Pentium[®] Pro Processor Specification Update

Release Date: April 1998

Order Number: 242689-027

1. *Mixing Steppings in MP Systems*

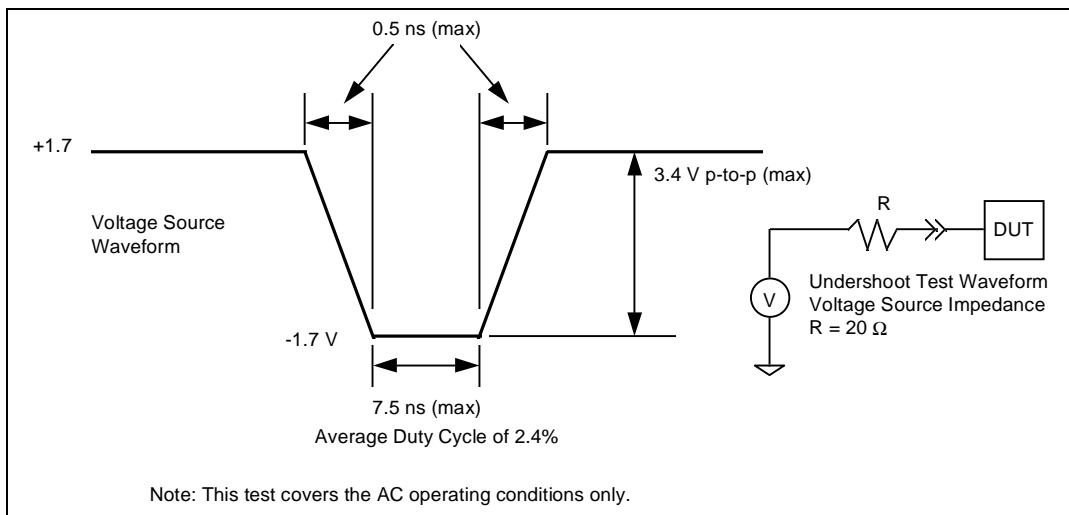
Though Intel recommends using identical steppings of processor silicon in multiprocessor systems whenever possible (as this is the only configuration which receives full validation across all of Intel's testing), Intel supports mixing processor steppings, and does not actively prevent various steppings of the Pentium Pro processor from working together in MP systems. However, since Intel cannot validate every possible combination of devices, each new stepping of a device is fully validated only against the latest steppings of other processors and chipset components.

The following list and matrix explain the known issues with mixing steppings:

- While Intel has done nothing to prevent different frequency Pentium® Pro processors within a system from working together, there may be uncharacterized errata which exist in such configurations. In mixed stepping systems, all processors must be run at an identical frequency (i.e., the **highest** frequency acceptable to all components).

- The workarounds for various errata must take all processors into account.
- Errata for all processor steppings present in a system will affect that system, unless worked around.

3. Errata 39 and 41 may be problematic for 3- or 4-way MP systems which use processor steppings previous to the sA1 stepping.

In the following table, "NI" implies that there are currently no known issues associated with mixing these steppings. An "X" implies that these steppings should not be used together in a system. A number indicates a known issue, and refers to the numbered list above. While there are no currently known issues associated with mixing cache sizes, Intel does not recommend or validate mixing cache sizes.

Figure 4-3. Stack Switch on a Call to a Different Privilege Level

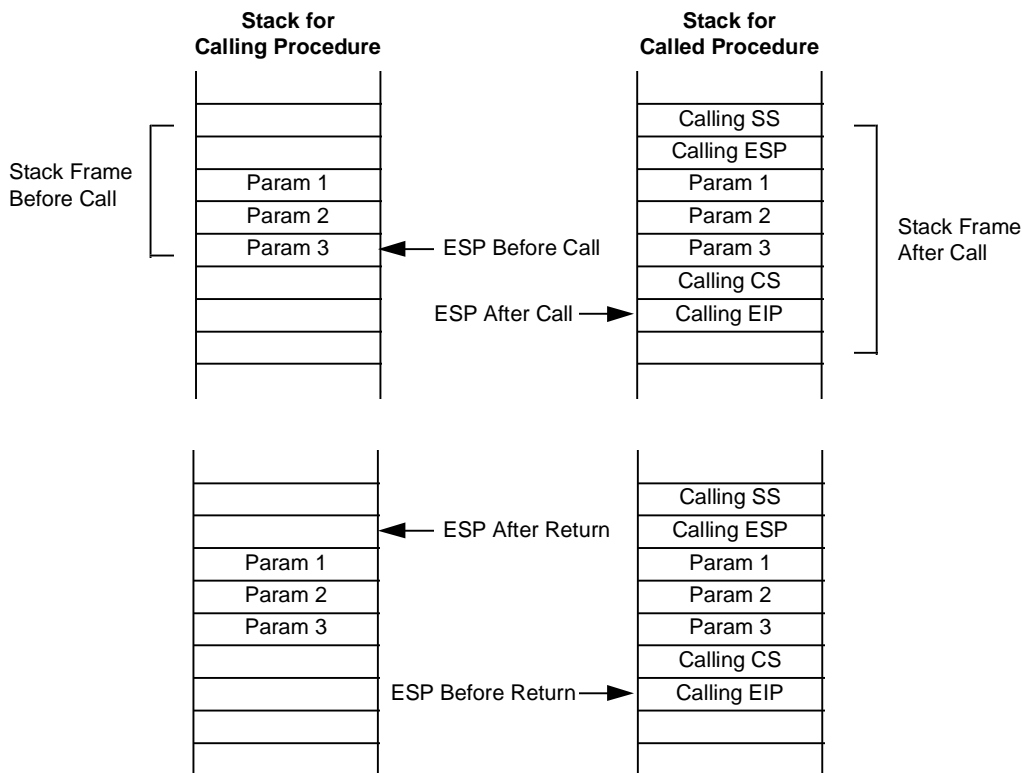
When making a call to a more privileged protection level, the processor does the following (see Figure 4-3):

6. Pushes the temporarily saved CS and EIP values for the calling procedure to the new stack.
7. Loads the segment selector for the new code segment and the new instruction pointer from the call gate into the CS and EIP registers, respectively.

8. Begins execution of the called procedure at the new privilege level.

When executing a return from the privileged procedure, the processor performs these actions:

1. Performs a privilege check.
2. Restores the CS and EIP registers to their values prior to the call.
3. (If the RET instruction has an optional n argument.) Increments the stack pointer by the number of bytes specified with the n operand to release parameters from the stack. If the call gate descriptor specifies that one or more parameters be copied from one stack to the other, a RET n instruction must be used to release the

parameters from both stacks. Here, the *n* operand specifies the number of bytes occupied on each stack by the parameters. On a return, the processor increments ESP by *n* for each stack to step over (effectively remove) these parameters from the stacks.

4. Restores the SS and ESP registers to their values prior to the call, which causes a switch back to the stack of the calling procedure.
5. (If the RET instruction has an optional *n* argument.) Increments the stack pointer by the number of bytes specified with the *n* operand to release parameters from the stack (see explanation in step 3).
6. Resumes execution of the calling procedure.

Note: On a return, parameters are released on both stacks if the correct value is given for the *n* operand in the RET *n* instruction.

Figure 4-4. Stack Usage on Transfers to Interrupt and Exception Handling Routines

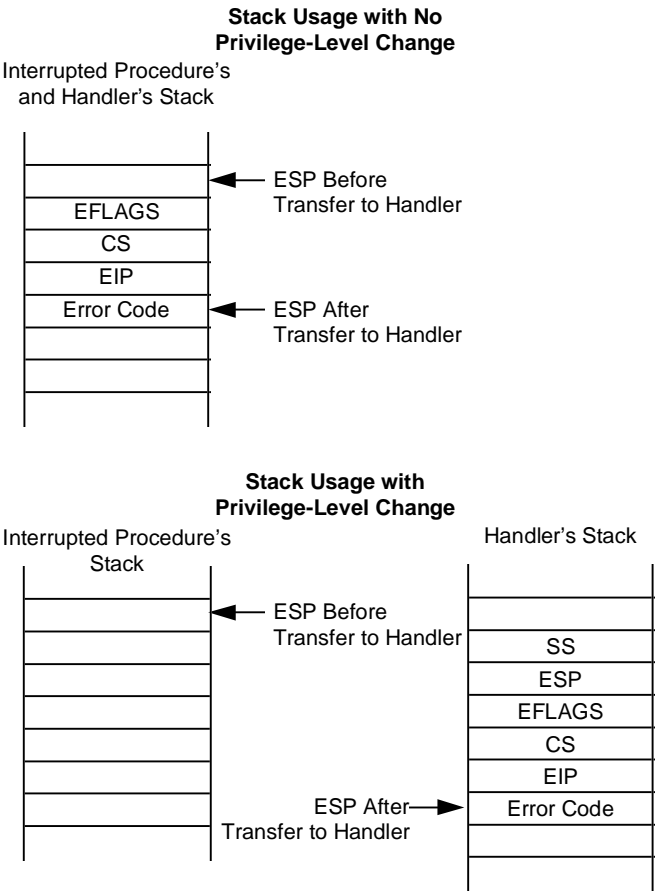
If no stack switch occurs, the processor does the following when calling an interrupt or exception handler (see Figure 44):

When executing a return from an interrupt or exception handler from a different privilege level than the interrupted procedure, the processor performs these actions:

1. Performs a privilege check.
2. Restores the CS and EIP registers to their values prior to the interrupt or exception.
3. Restores the EFLAGS register.
4. Restores the SS and ESP registers to their values prior to the interrupt or exception, resulting in a stack switch back to the stack of the interrupted procedure.
5. Resumes execution of the interrupted procedure.
